SUBJECT: TORQMATIC CONVERTERS - ALL MODELS OF TC-300 SERIES - ADDITION OF "O" RINGS P/N 7374627 TO THE CONVERTER HOUSING P/N 6754489.

SUBJECT: TORQMATIC CONVERTER - TC-200 SERIES - ALL MODELS - RELEASE OF SEAL RING P/N 3713622 TO REPLACE SEAL RING P/N 3702082.

SUBJECT: TORQMATIC CONVERTER - TC-300 SERIES - ALL MODELS - REPLACING SINGLE ROW CONVERTER PUMP BEARING P/N 903209 WITH A DOUBLE ROW ANGULAR CONTACT BEARING P/N 905209 FOR INCREASED BEARING LIFE.

SUBJECT: TORQMATIC CONVERTER - TC-200 & 300 SERIES - ALL MODELS - ADDITION OF TWO (2) SCREWS P/N 113998 TO RETAIN CONVERTER ASSEMBLY WHEN REAR BEARING RETAINER OR HOUSING IS REMOVED.

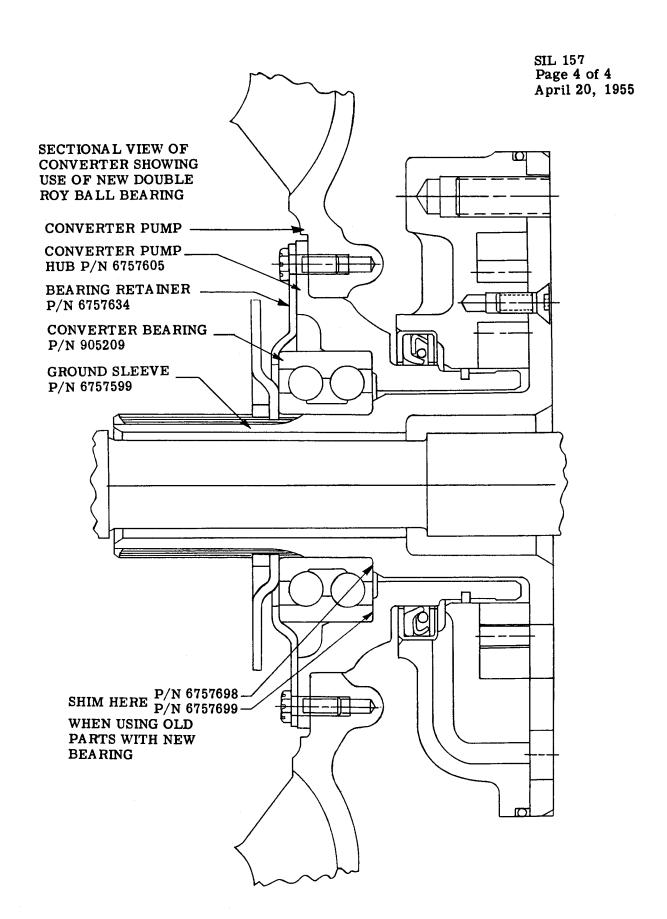
- 2.1 In order to use the new bearing in units before S/N 7144, two (2) Shims P/N 6757698 and 6757699 were released. Proper use of these shims with the new bearing is as directed below.

- 2.1.1 When installing a new Bearing P/N 905209 in the converter pump Hub P/N 6754519, use one (1) Shim P/N 6757699 between the bearing outer race and bearing shoulder in the converter pump hub. The other Shim P/N 6757698 is used between the bearing inner race and bearing shoulder on the converter ground Sleeve P/N 6754528. (See sketch).

- 2.1.2 Use the new bearing Retainer P/N 6757634 (old Retainer P/N 6755803 cannot be used with the new bearing).
 - 2.1.3 With use of the new bearing, the Spacer P/N 6755896 is not required.

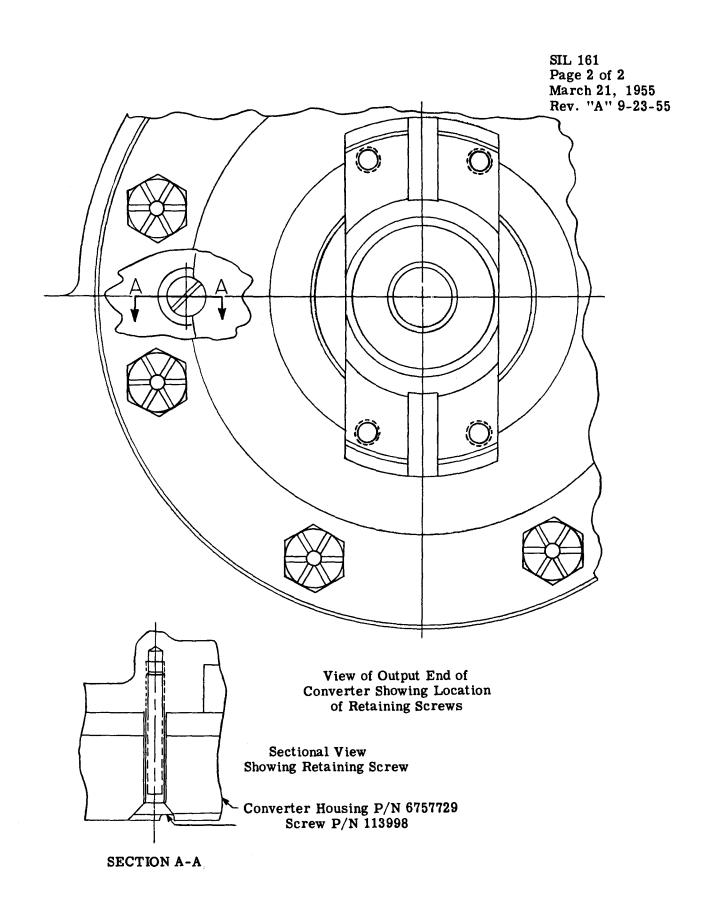
Effective with Torqmatic Converter TC-200 Series Serial No. 9357 and Torqmatic Converter TC-300 Series Serial No. 7626, two (2) flat head screws P/N 113998 have been added to hold the converter assembly together when the eight (8) bearing retainer, bearing housing or rear disconnect housing bolts are removed.

In order to accomplish this, two (2) 9/32" holes were drilled (on the horizontal center line) through the converter housing P/N 6757729. Mating holes in adjacent parts are drilled as listed below:

The holes in the converter housing are counter-sunk at the rear face to recess the flat head screws below the mounting face of the bearing retainer, bearing housing or rear disconnect housing. (See sketch).

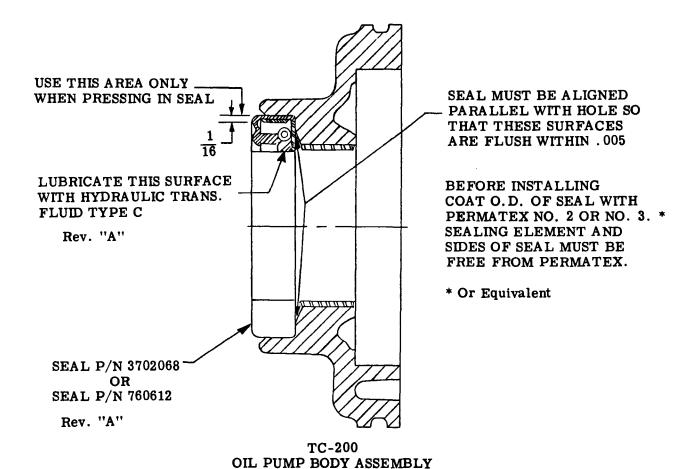
As a product improvement and to provide a better lip type seal with longer life, Seal P/N 3702068 (TC-200) has been replaced by Seal P/N 760612 and Seal P/N 6753849 (TC-300) has been replaced by Seal P/N 6758213.

When necessary to replace either seal in the field, the two (2) attached sketches should be referred to. A hand-operated arbor press should be used for pressing in the new seal whenever possible. A hydraulic press must never be used. Use of a hydraulic press could result in rupturing the seal or seal seating surface.

TO PREVENT DISTORTION
OF PUMP BODY RECESSES,
PRESS SEAL IN PUMP BODY
WITH MINIMUM FORCE
REQUIRED TO SEAT SEAL

TC-300 OIL PUMP GEAR AND BODY ASSEMBLY P/N 6757086

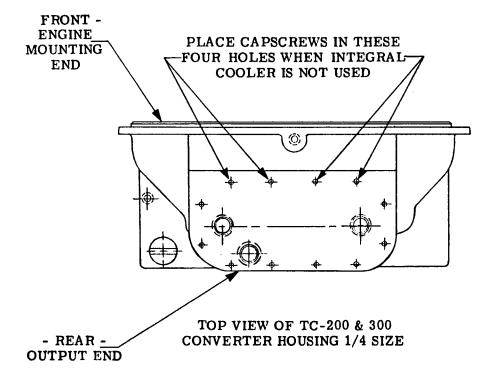
> Before Installing Coat O.D. of Seal with Permatex No. 2 or No. 3. * Sealing Element and Sides of Seal Must be Free from Permatex

HEADER PUNCH TC-300, CRT-3330 & CTP STATOR ASSEMBLY

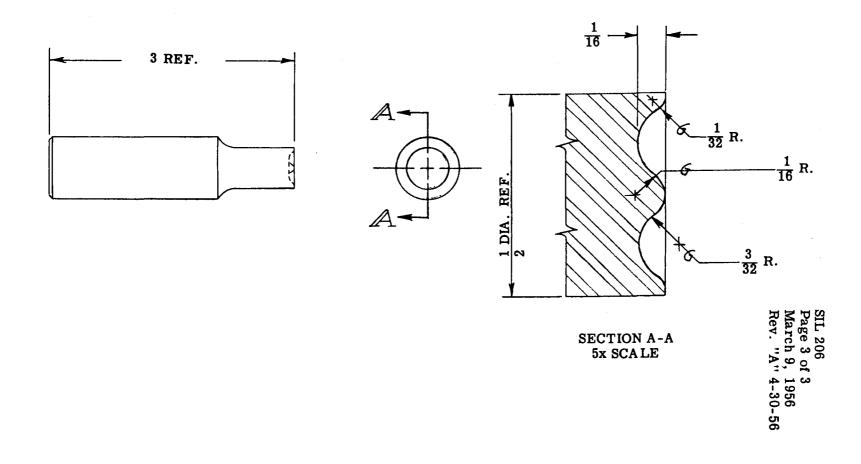
- A. Hand operated arbor press.
- B. Rivet header patterned after attached sketch.
- C. Anvil suitable for supporting the preheaded end of the rivet.
- D. Clamps capable of holding pieces in position during riveting operation.

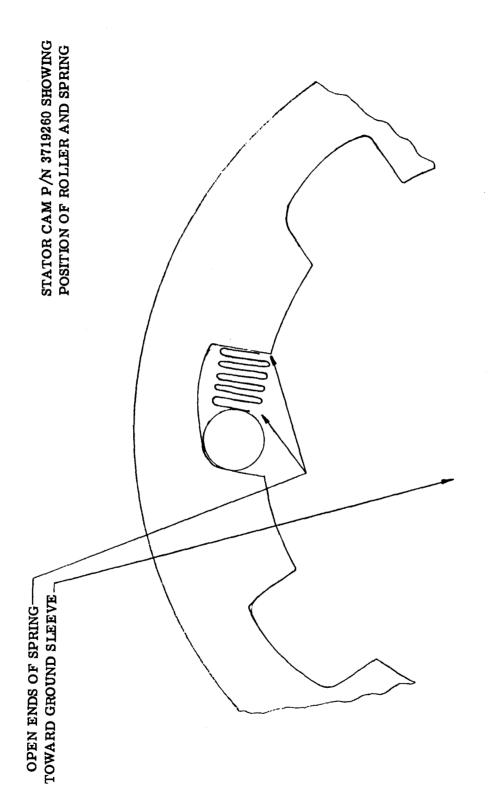
As a product improvement, a new stator assembly has been released for the subject models. The primary change in the assembly consists of the addition of convoluted roller springs and the deletion of coiled roller springs.

The new springs should be installed as shown in the attached sketch.

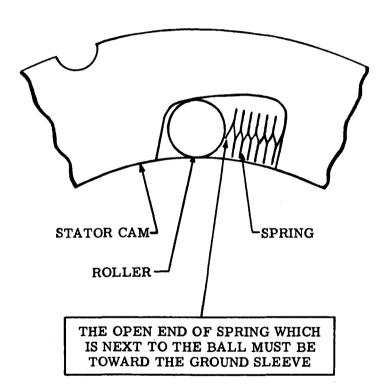
New freewheel roller springs, P/N 6771296, have been released for use in CRT-3331 transmissions and TC-300 converters. These springs supersede springs P/N 6754999.

The new springs, which are stronger than the old springs, insure fast, uniform engagement of the stator rollers. This will reduce the possibility of stuck stators and will decrease wear on the rollers and on the roller race.

The new springs should be installed in the stator cam as shown in the sketch on the reverse side of this page.
